In the Drawings:

REMARKS

1. **Amendments To Drawings:**

Figure 11

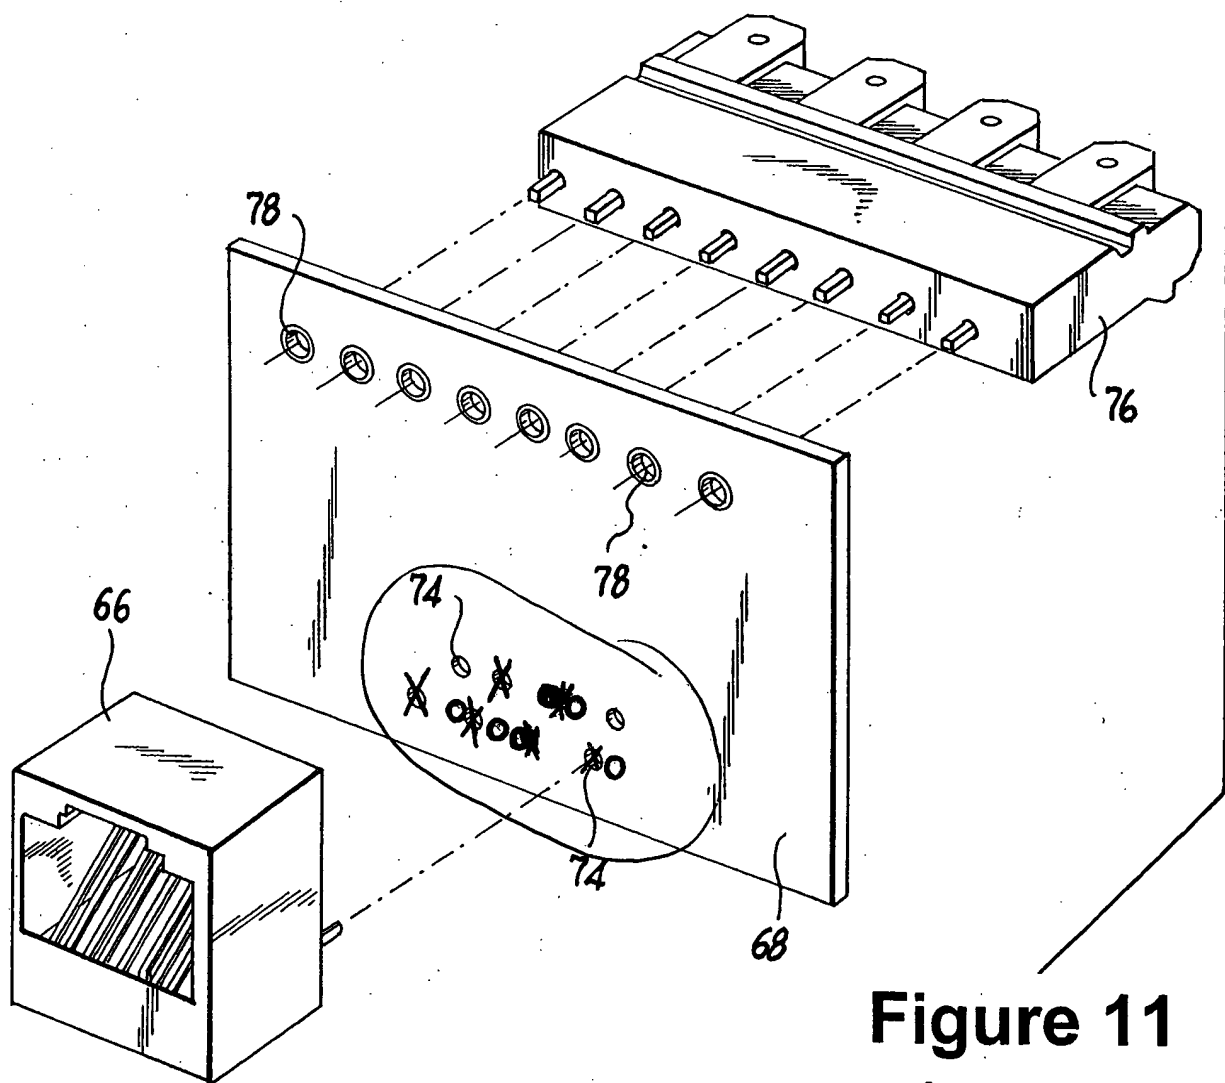
FIG. 11 has been amended to make the spacing between the upper row of PCB contacts 74 correspond to the spacing (shown in FIG. 3) between the upper row of extensions 46 of rear portions 40 . FIG. 11 has been further amended to make the spacing between the lower row of PCB contacts 74 correspond to the spacing (shown in FIG. 3) between the lower row of extensions of rear portions 54. This amendment is supported by the specification, for example, but not limited to, at page 18, lines 13-14, which states that “[m]odular housing 66 with insert 10 is electrically connected to a printed circuit board (‘PCB’) 68” and at page 18, lines 18-19, which states that the “signal transfers from inserts 10 via extensions 46 and 56 of rear portions 40 and 54 respectively, into PCB 68 via PCB contacts 74.
